## STATION FLATS JSP 23-02

Public hearing at the request of Cypress Partners, LLC for recommendation to the City Council for Amendment of the Consent Judgment that governs development of the property. The subject property is located on the east side of Wixom Road, south of Grand River Avenue (Section 17). The applicant is proposing 157 apartment units in a four-story building. The Consent Judgment permits retail uses conforming to the B-2 Community Business standards. The proposed use is most consistent with the RM-2 High-Density Multiple Family Residential District.

REVIEW	RESULT	DATE	COMMENTS
Planning	<b>Approval Not recommended</b>	6-12-23	<p><b>Deviations to RM-2 standards:</b></p> <ul style="list-style-type: none"> <li>• <b>Reduction in parking setbacks along the north and west for the out-lots</b> <i>(Supported as adjacent to other parking areas of center)</i></li> <li>• <b>Maximum percentage of efficiency and 1-bedroom units exceeded.</b> <i>(Supported as a balance in unit mix is provided)</i></li> <li>• <b>Maximum length of building exceeds 360 feet (368 feet proposed)</b> <i>(Supported as pedestrian entrances present)</i></li> <li>• <b>Buildings not oriented 45 degrees t

Figure 1. Station Flats Development Site  
 City of Novi Regulated Woodland Map  
 Bold red line = property boundary;  
 Green areas = City-regulated woodlands

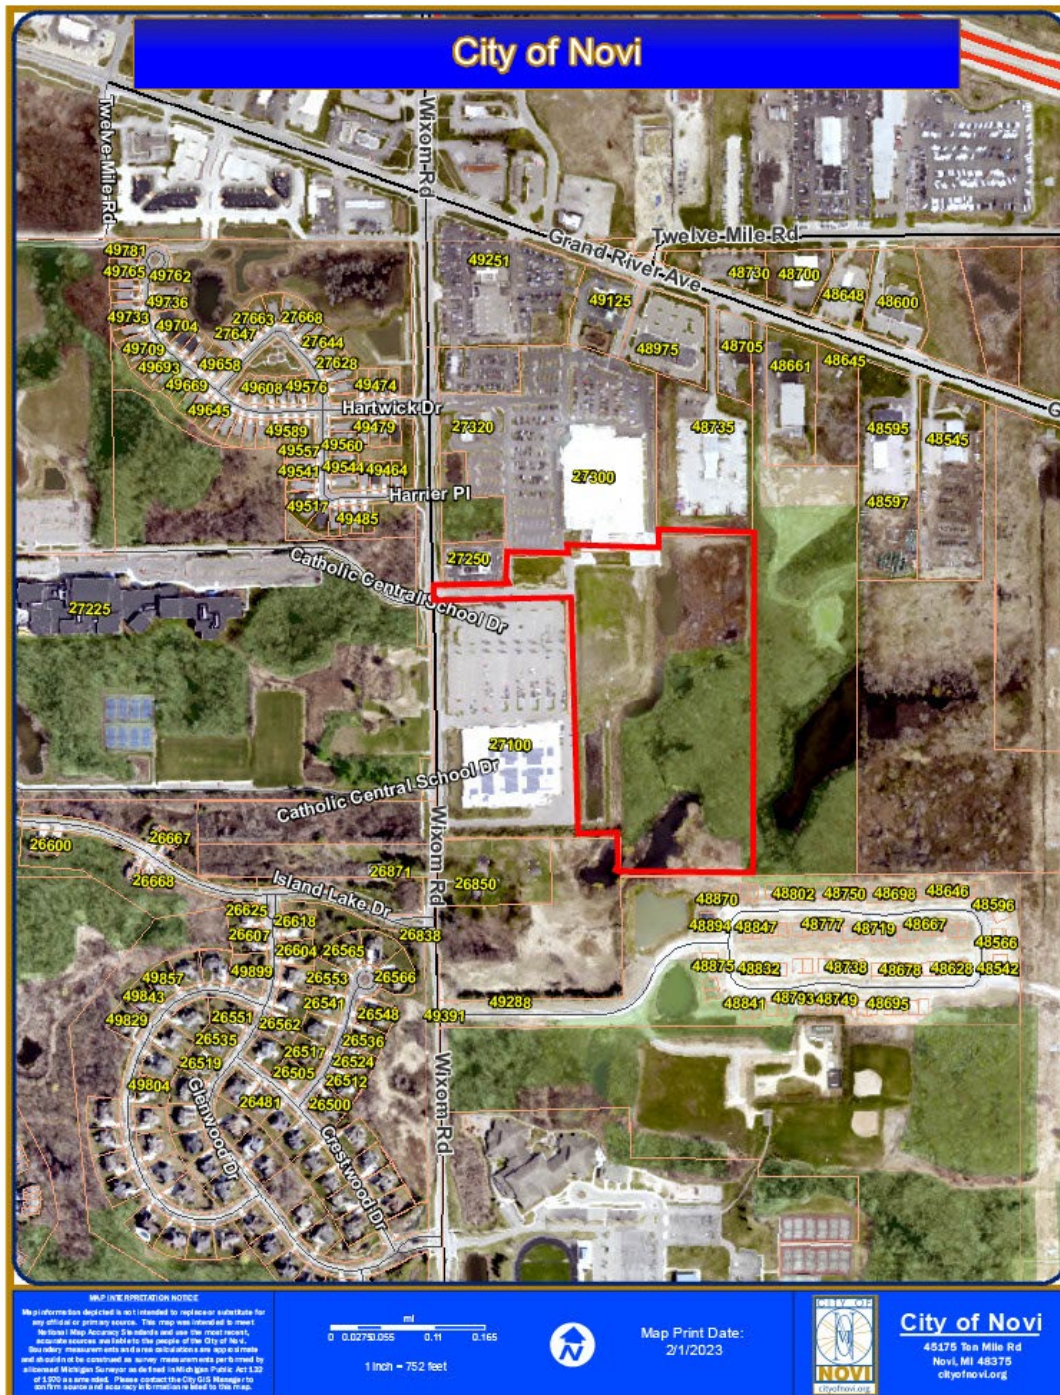
DRG reviewed the preliminary site plan set for conformance with the City of Novi’s Woodland Protection Ordinance, Chapter 37. Based on our review of the site plan, and the City of Novi Official Regulated Woodlands Map (see Figure 1) - City regulated woodlands are present on the site. The woodlands will not be impacted by development because they are located within an existing wetland/watercourse easement on the east side of the property that will be protected. However, **regulated woodland replacement trees planted as part of the Novi Promenade will be impacted and require replacement.**

Figure 2. Novi Promenade Approved Woodland Mitigation Landscape Plan

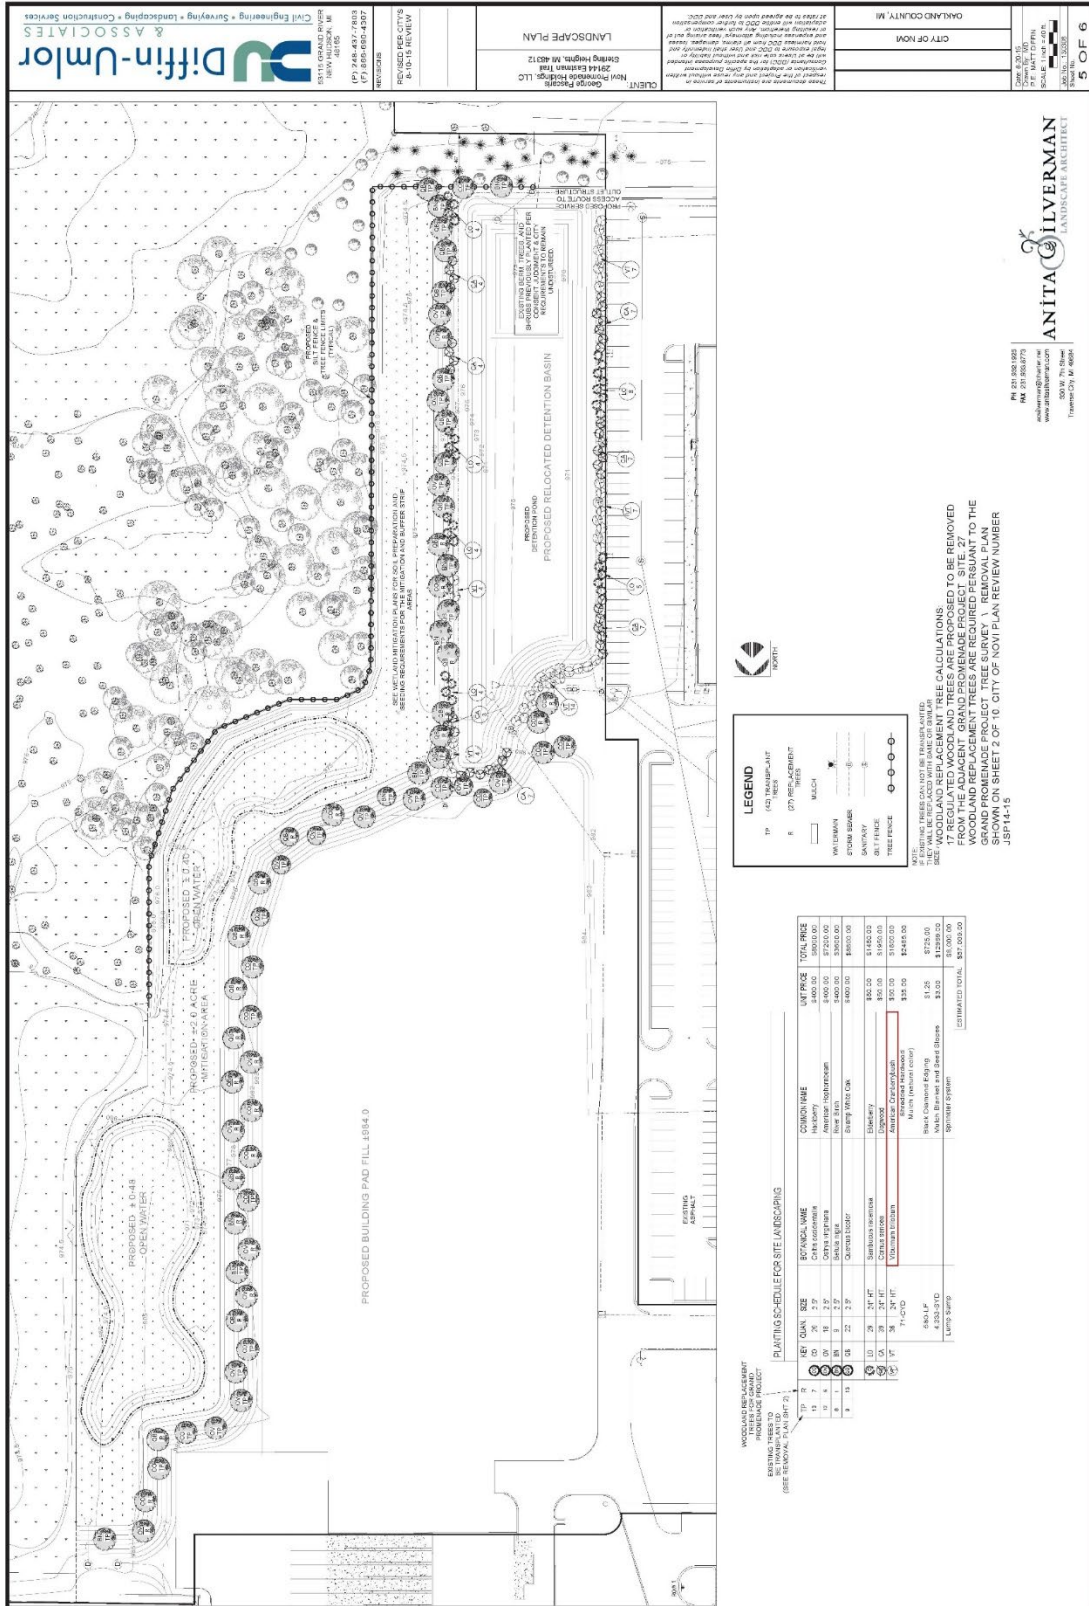
1. **Woodland Replacements.** While regulated woodland trees are protected – the plan proposes the removal of trees that were planted as woodland replacements for the Novi Promenade development (Figure 2). These trees are regulated, and their removal requires replacement.
2. **Tree Inventory.** As stated in the Landscape Review memo prepared by Rick Meader, City of Novi Landscape Architect, the **woodland replacement trees are required to be inventoried and shown on the plan and in the regulated tree table.** The plans and tree table should also indicate if a tree will be removed or preserved and include associated tree protection fencing if preserved.

**WOODLAND REVIEW #2 COMMENT: Sheet T-1.0** The location of the woodland replacement trees planted for the Novi Promenade development are shown on the plans but there is not a tree table listing the trees and tree replacements have not been calculated and provided. Sheet T-1.0 states that no woodland replacements are required because “no woodland trees greater than 8” DBH are being removed.” This is incorrect per comment #1 – the woodland replacement trees are considered regulated. Revise plans to address comments.

**The woodland (tree preservation plans T-1.0 and T-1.1) have been revised.**
